OSSF Inspection Sheet

Permit of Authorization to Construct an On-Site Sewage Facility Permit Valid For One Year From Date Issued

Higher Ratings LLC
Majid Howiatdost JR.
9131 Alpine Trail San Antonio TX, 7850
Designed for:
Angelica Sanchez
NEW AEROBIC SEPTIC SYSTEM
DRIP IRRIGATION

OSSF Design for Lake of the Hill Estates BLK22 LOT182
aka 949 Cimarron Spring Branch TX 78070
Angelica Sanchez

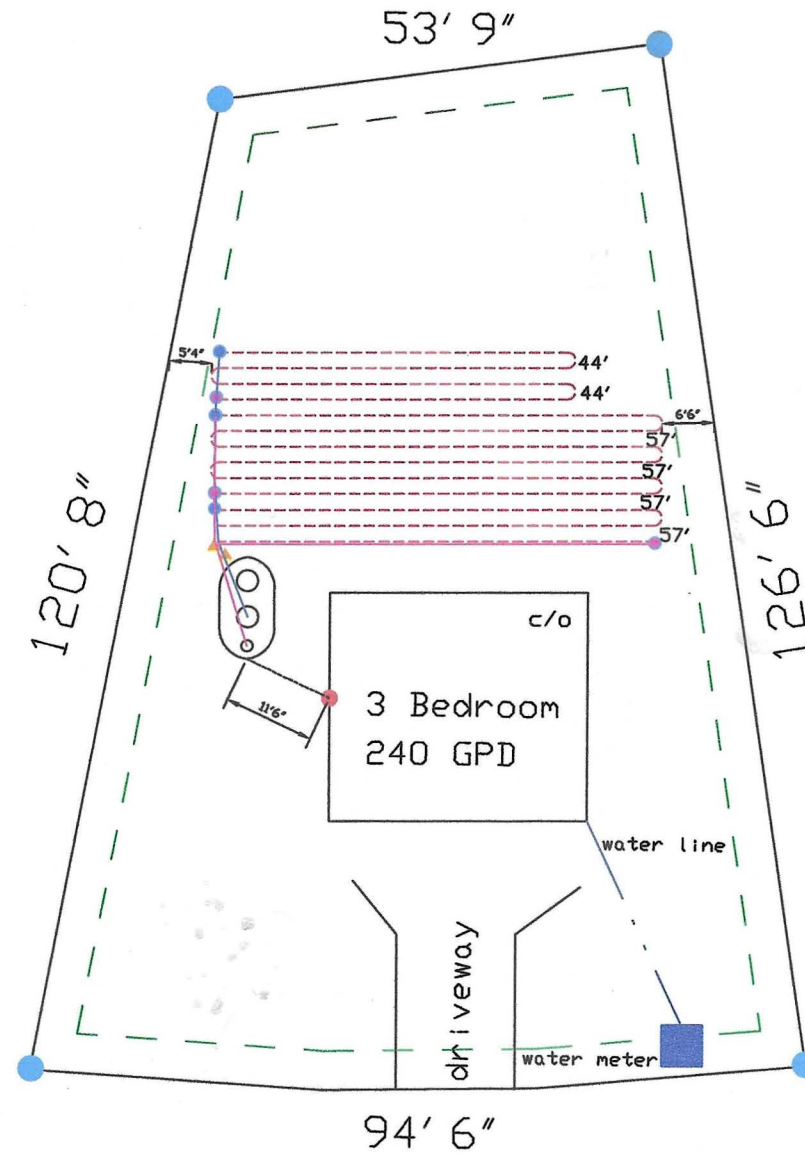
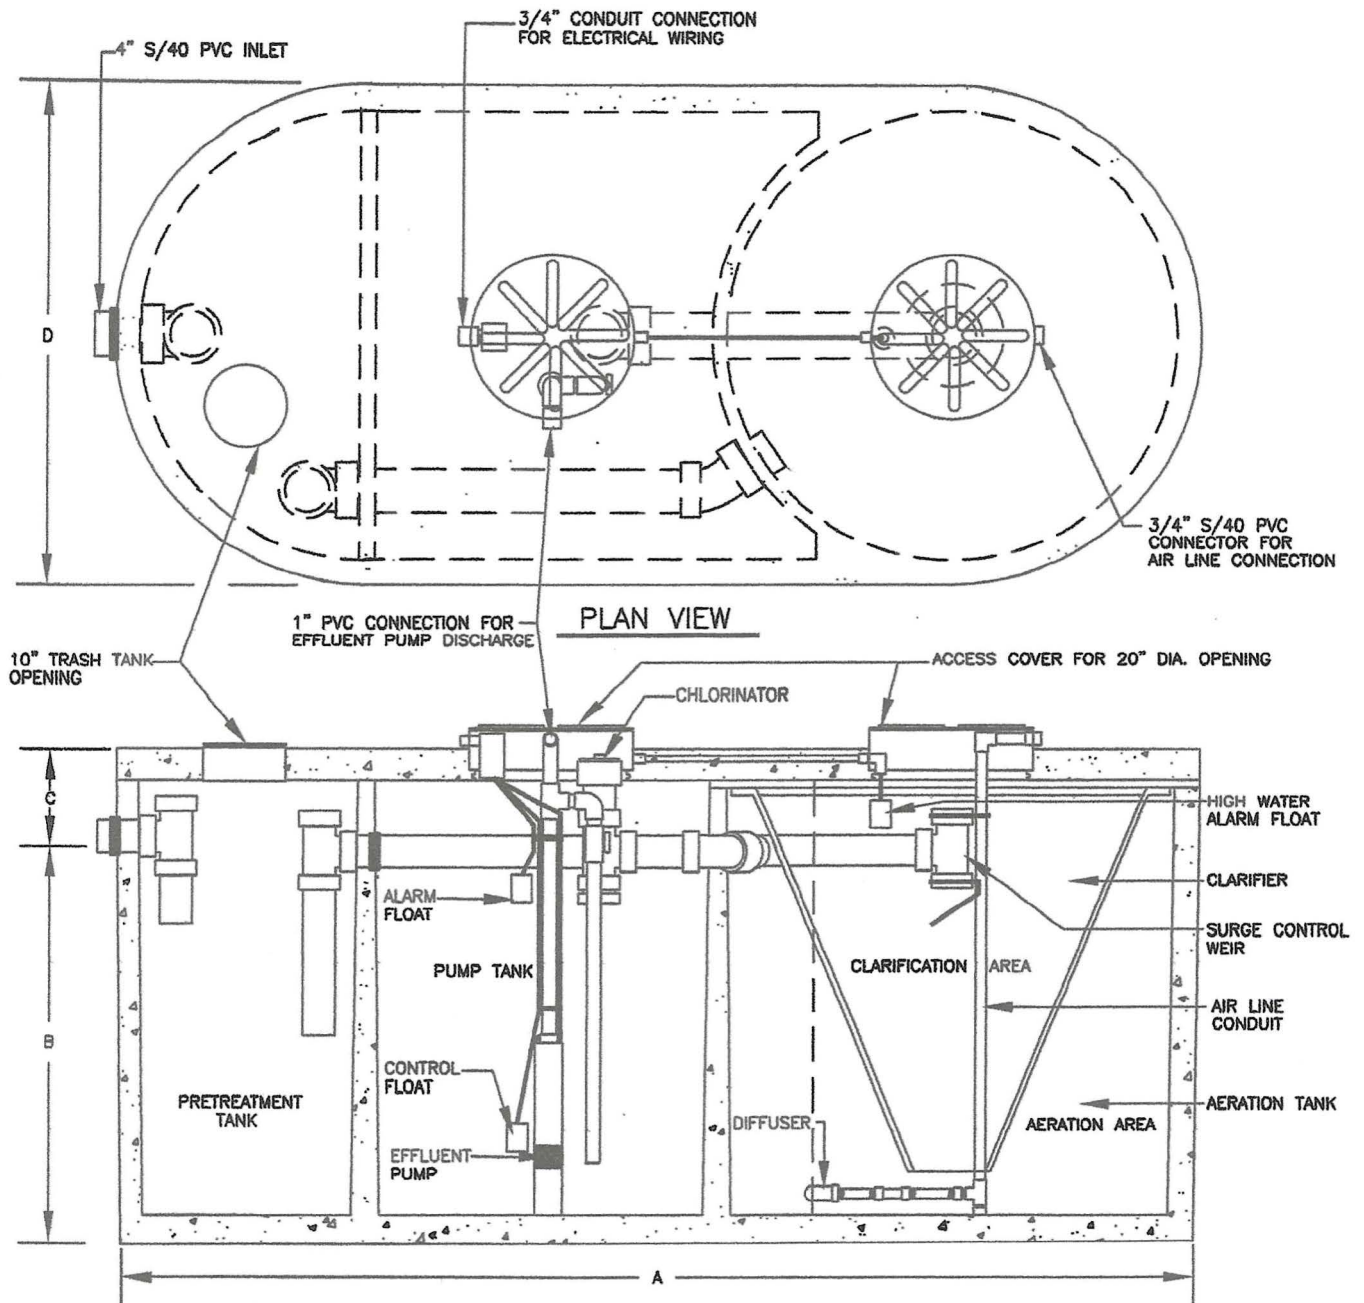
Probing in the area of the proposed drip field showed no more than 2" of soil covering surface bedrock

This Design includes an attached drawing:
Dated 03-22-2024 Revised 7-3-2024
Use Clear Stream 600 GPD or Equivalent ATU
